SUBJECT: Freedom of Information Act Request No. FA-22-0092; Copy of Documents Related to SPK-201900889, The Pride of America Mine Project

YULE CREEK MITIGATION PLAN

RE: Response to June 17, 2021 USACE Additional Information Request (SPK-2019-00889)

RE: Addendum to CSQ's July 19, 2021 Response to USACE's June 17, 2021 Additional Information Request (SPK-2019-00889)

Figure 1. Design of a flatbed railcar bridge over Yule Creek near the diversion point. This crossing design image was annotated from ERC’s March 2021 Yule Creek Mitigation Plan.

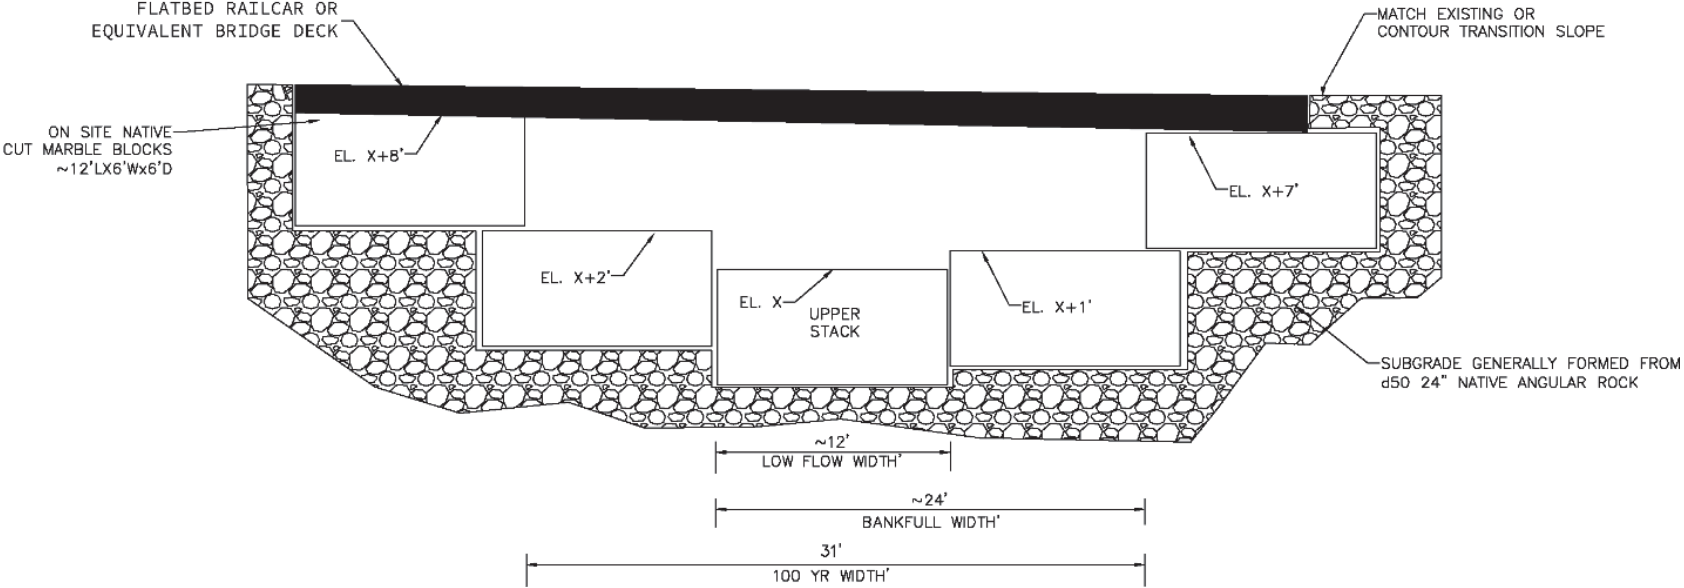
b. Design drawings for the bottomless culvert proposed to replace the culvert crossing near the upstream(south) end of the project area.

CSQ commits to not constructing any additional surface structures within the design mitigation corridor of the eastern alignment of Yule Creek, except for crossing structures. All crossing structure (e.g., the new bottomless culvert that will replace the current corrugated steel culvert) will be wide enough to span the full 31-foot wide 100-year flood width of the designed channel as detailed in the March 22, 2021 Yule Creek Mitigation Plan designed by ERC and previously submitted to USACE.

As shown in Figures 1 and 2, a flatbed railcar bridge or equivalent will be used to span the creek and will be anchored to marble blocks on both side of the crossing. The bridge will have the load capacity required for CSQ's equipment. Marble blocks will be cut to size on site and backfilled to both side slope elevations to ensure stability.

Figure 5. Design of 12'W x 6'H x 8'L prefabricated box culverts.

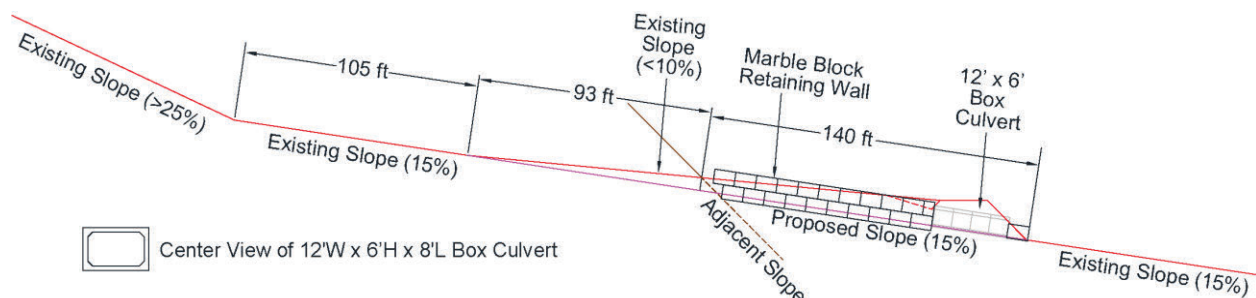
USACE recently advised CSQ that additional mitigation (beyond those mitigation measures presented in CSQ's July 19, 2021 response) would likely be required. In order to expedite the permitting process and in view of the short construction season at the PAM, CSQ agreed to submit an addendum to its July 19 submittal identifying additional mitigation measures.

Figure 5 details a representative design utilizing 12'Wx6'Hx8'L box culverts for the crossing. The culverts will begin along the eastern edge of the roadway. Outlet protection may be provided by additional waste marble blocks. Current designs include four 8-foot-long culvert sections would provide sufficient space for the roadway totaling to a 32-foot culverted section beneath County Road 3c. West of the box culverts would be protected by a waste marble block retaining wall similar to the walls utilized within the quarry (Figure 6).
